ADDENDUM #1
FOR
20241092- BX508 BROSIUS STEICHMAN HALL – UPDATE NURSERY

Camp Brosius
Indiana University
N8089 Co. Rd. P
Elkhart Lake, Wisconsin 53020

August 19, 2025
DDS Project No. 24-067

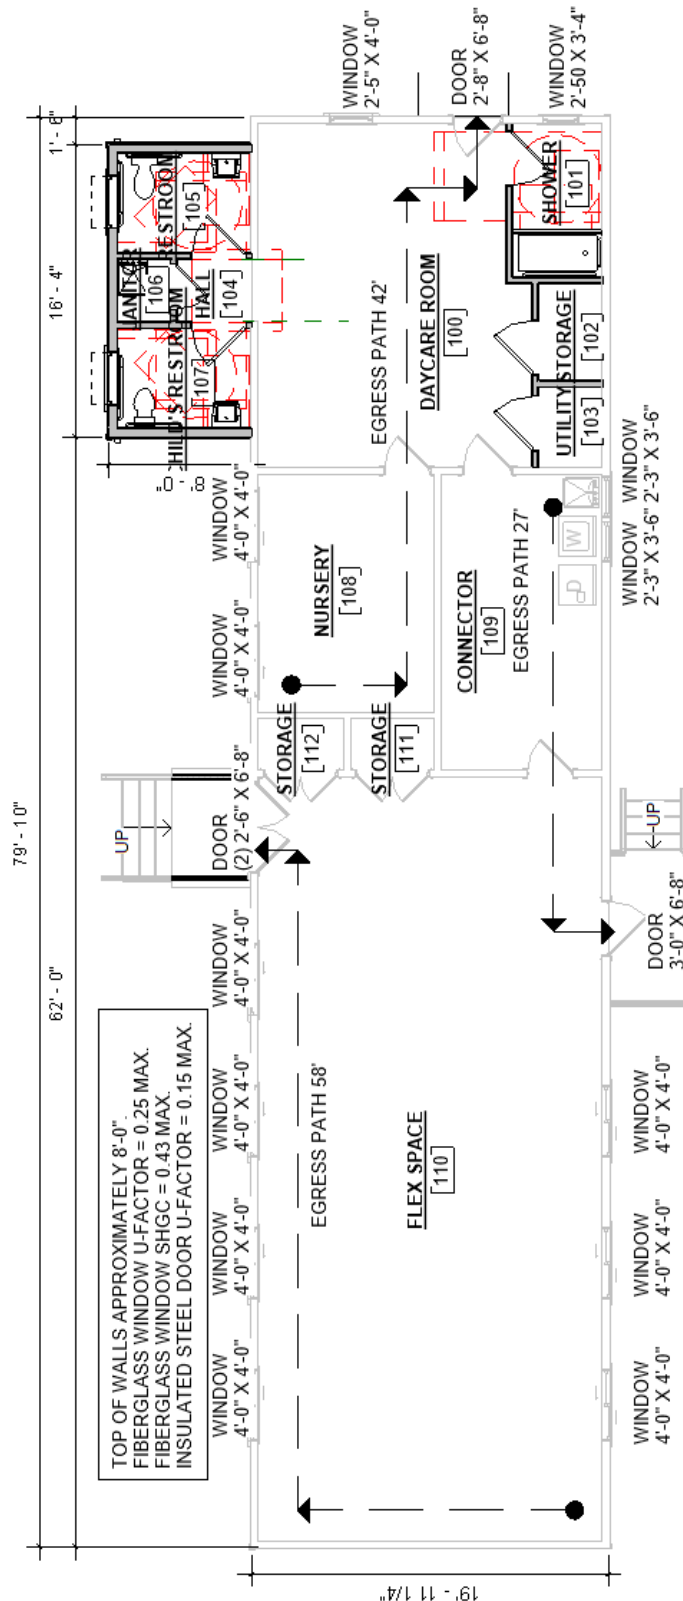
16. Questions regarding the existing door on east end of building.

17. Would you provide a plan of the entire building and detailed scope of work for Alternate No. 1? I'm looking for dimensions of the areas, what is to be removed & replaced (ceiling, walls, flooring, base, windows, etc.), size of wall & floor members to be insulated with spray foam, etc.

Replace existing door on east end of building with new insulated door and frame. Match existing appearance. See drawing below for U-factor. Replace screen door to match existing.

This information has been included as part of this Addendum. See attached drawing below. See item 12 above for additional information regarding Alternate #1 scope of work. Exterior walls are 2x4 studs. Floor joists appear to be 2x6 construction. G.C. shall verify all dimensions.

PROJECT SCOPE

BASE BID:

- FIX GRADING ON WEST END OF BUILDING
- NEW FOUNDATION AND FLOOR STRUCTURE ON WEST END OF BUILDING AS SHOWN
- REMODEL EXISTING TOILET ROOM TO BATHING ROOM
- REMODELED UTILITY AND STORAGE CLOSETS
- NEW FLOOR, WALL, AND CEILING FINISHES ON WEST END OF BUILDING AS NOTED
- NEW TOILET ROOM ADDITION TO THE NORTH
- PLUMBING CONTRACTOR SHALL VERIFY EXISTING SEPTIC TANK/ SYSTEM CAN MANAGE ADDITIONAL TOILET AND LAV FIXTURES.

ALTERNATE BID (INFORMATIONAL PRICING):

- INCLUDE QUOTE TO INSULATE ENTIRE EXISTING BUILDING STRUCTURE. THIS INCLUDES SPRAY FOAM WALL INSULATION, R-49 BATT CEILING INSULATION, AND FULL-THICKNESS BATT FLOOR INSULATION, AND EXTERIOR WINDOW AND DOOR REPLACEMENT.

CAMP BROSIOUS
NEW OFFICE BUILDING
SEWER AND WATER HOOKUP

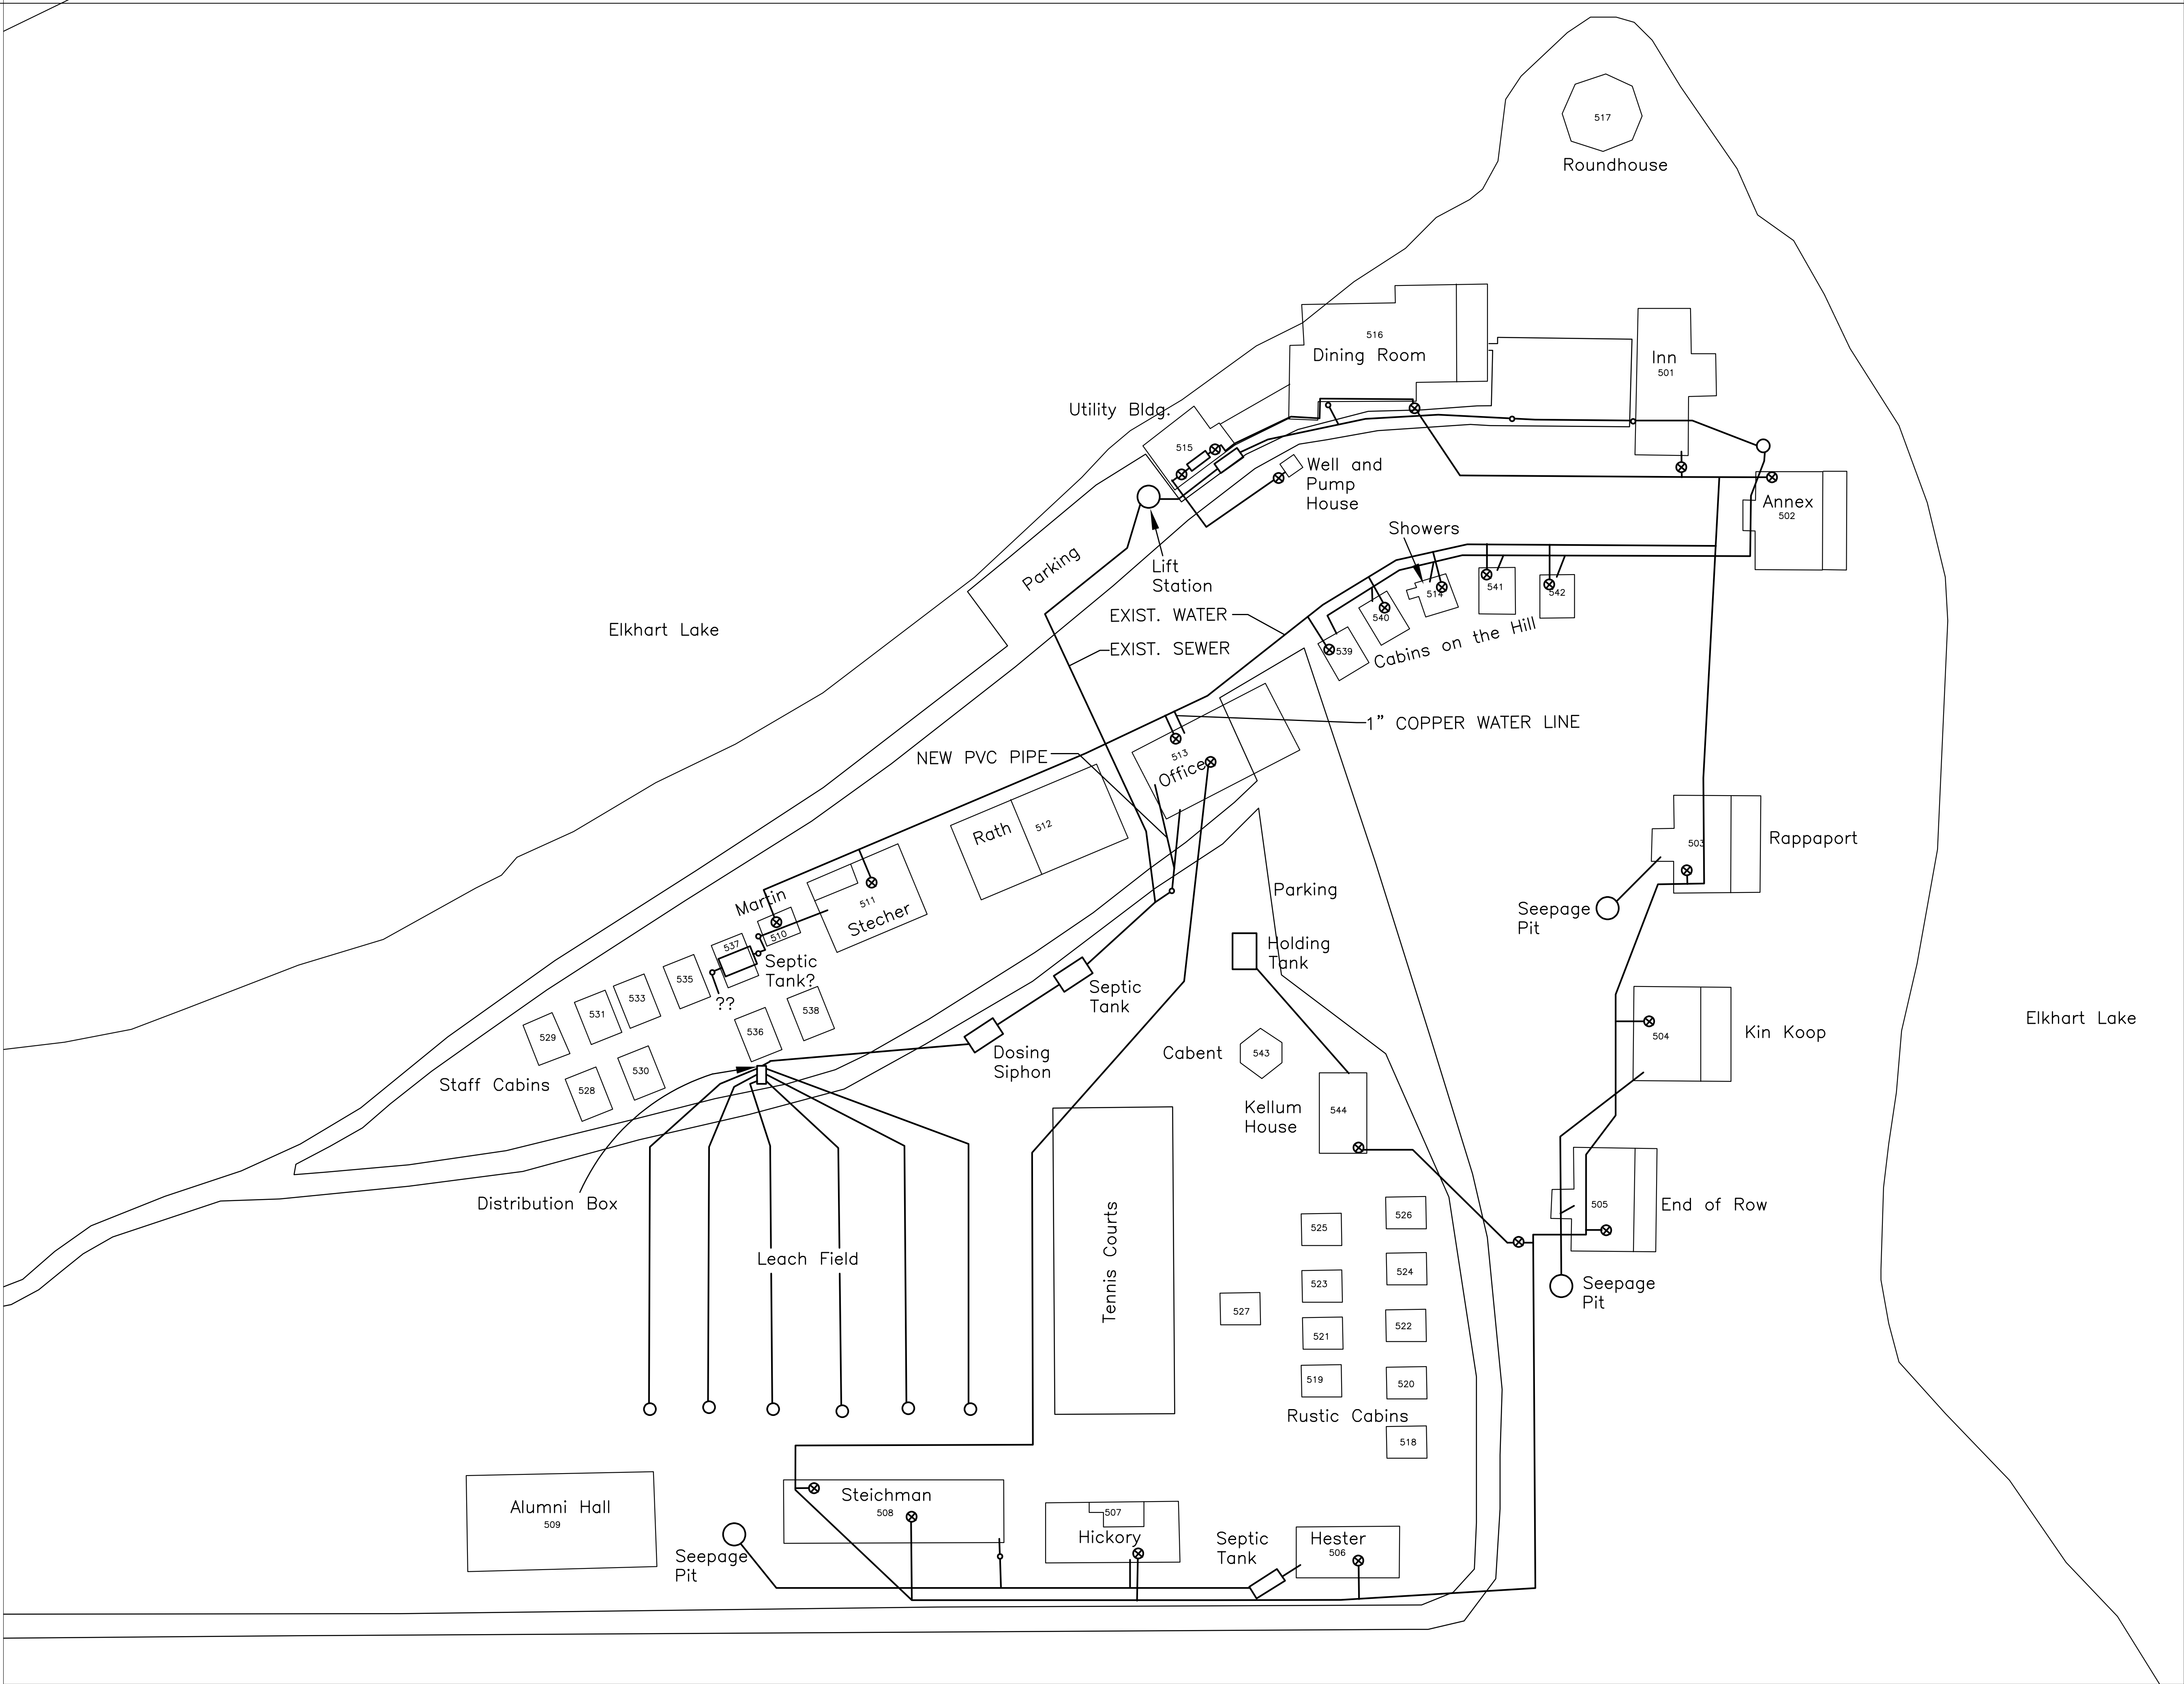
2. A drawing showing sewer and water hookups has been included in this Addendum. See attached drawing.
